Subject: SRWRF – CO#7 Justification

MSD
PBU215501L

**South Regional Water Reclamation Facility
PCO #015 - Plant Reuse Water Pump Revised Duty Rating**

PCO #041
 Grit Equipment and Grit
 Channel Modifications

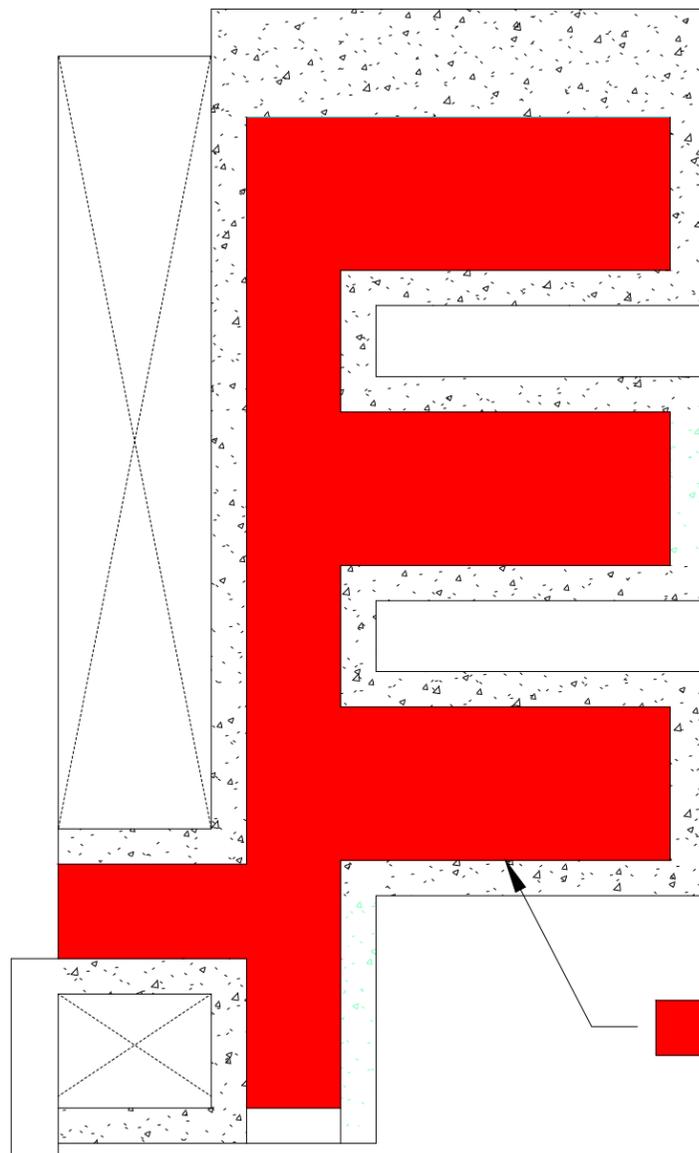
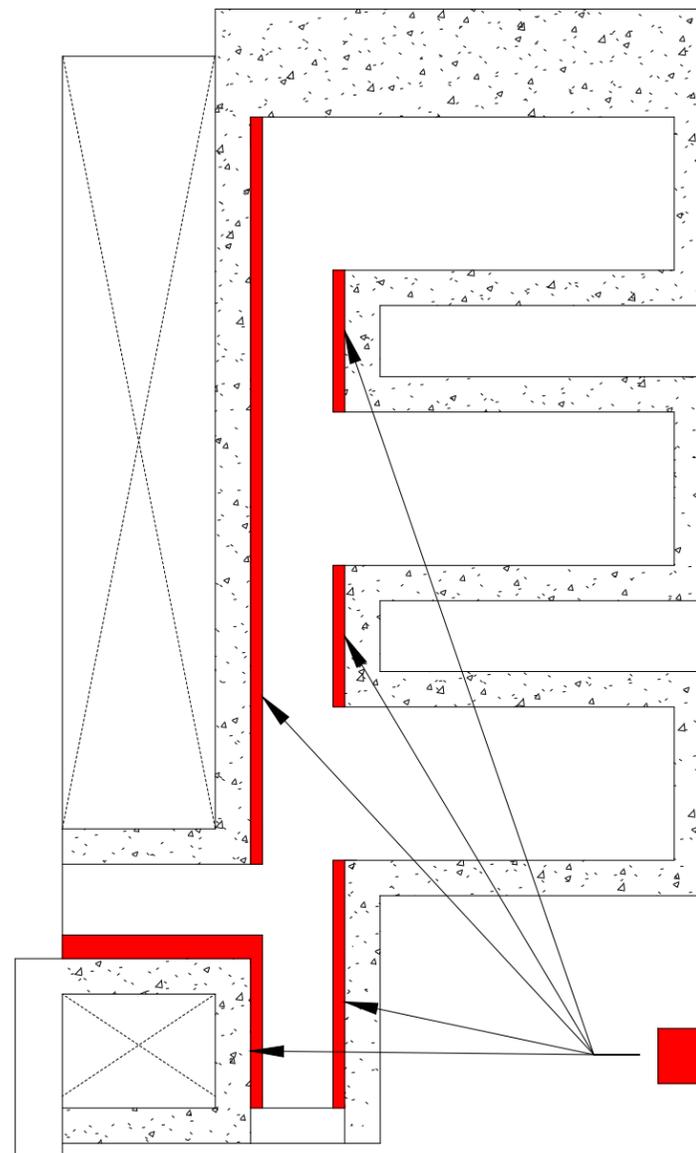
The equipment cost for the grit removal equipment escalated due to pandemic-induced inflation from the date of the original purchase order of December 2020 to the fabrication date of July 2022. In addition, the grit channel structure was redesigned to produce enhanced velocity entering the unit.

Additional Channel Slab Concrete (Elev. 37.00 - 38.00)
